# MIAMI BEACH

Staff Report & Recommendation

Historic Preservation Board

SUBJECT: HPB18-0198, **835 Alton Road.**

*Original west elevation permit plan, 14479*

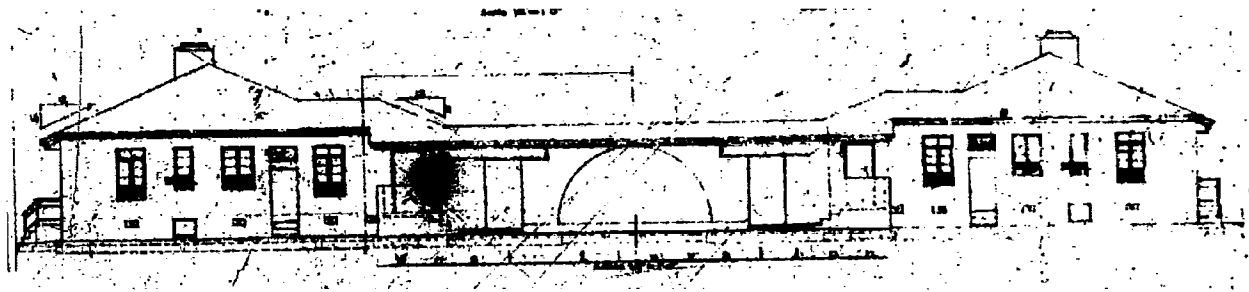
The applicant is proposing to construct an 875 square foot lobby located behind the existing covered entry feature along Alton Road. As part of the new lobby enclosure, glass doors with transoms are proposed within the existing open-air passageways and a new storefront window system is proposed within the open arch feature. Staff has no objection to the glazing system within these openings. However, staff recommends that the mullion configuration of the arched opening be further refined in a manner more consistent with the Med Deco style of architecture. Additionally, the existing roof over the covered entry is proposed to be replaced with a new hip roof with a higher ridge line in order to conceal new air conditioning equipment on courtyard side of the roof. Staff recommends that the applicant explore the use of lower profile mechanical equipment and/or lowering a portion of the roof where the equipment will be placed or the introduction of a wall mounted spilt system facing the interior courtyard that could be screened with landscape, in lieu of increasing the height of the roof along the primary elevation beyond the ridge line of the adjacent portion of roof. Finally, the applicant is proposing to enclose a portion of the curved wall outdoor passageways located to either side of the entry feature. Staff is not opposed to this modification, as it could be easily reversed in the future. However, staff would recommend that a score line be introduced in the new stucco finish to delineate the extent of the original openings.
